Rationale for the proposed amendments to Regulation No. 110 (Specific components for CNG)

Submitted by the expert from ISO (TC 58/SC 3)

Proposal - Alignment of certain items with ISO 11439:2013 - Proposed Revisions to:

Regulation No. 110

Figure HA.1 - Cylinder orientation and layout of exposure areas

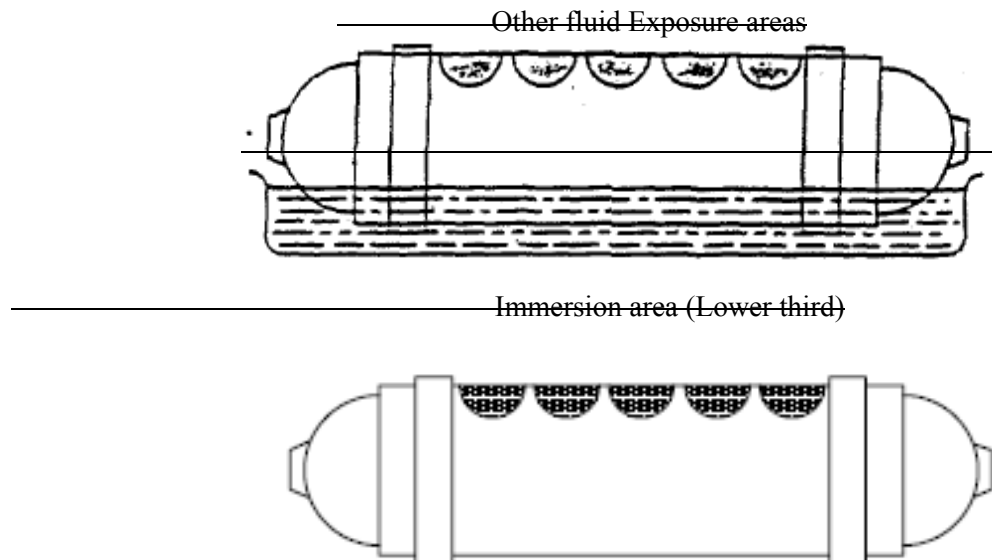
Cylinders will be tested horizontally and nominally divided along their horizontal centreline into "upper" and "lower" sections. The lower section of the cylinder will be alternatively immersed in road salt/acid rain environment and in heated or cooled air.

The immersion part of the test was eliminated in ISO 11439 as the concentrated exposures to the 5 chemicals would provide a more severe test condition.

The upper section **of the cylinder** will be divided into 5 distinct areas and marked for preconditioning and fluid exposure (see Figure HA.1). The areas will be nominally 100 mm in diameter. The areas shall not overlap on the cylinder surface. While convenient for testing, the areas need not be oriented along a single line, but shall not overlap the immersed section of the cylinder.

Figure H.2

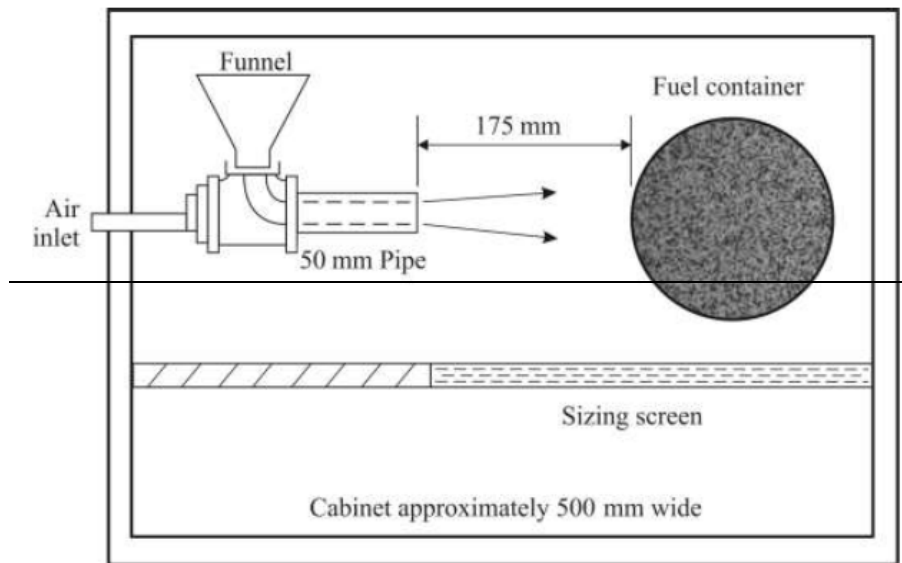
Machine constructed according to the design specifications shown in Figure H.2. This procedure for operation of the equipment shall follow that described in ASTM D3170, Standard Test Method for Chip Resistance of Coatings with the exception that the cylinder may be at ambient temperature during gravel impact;

It was found in testing that the gravel impact had no apparent effect on the integrity of cylinders, or any protective coating – the pendulum impact was a much more severe test of a coating and its ability to prevent chemicals from reaching the underlying composite reinforcement.
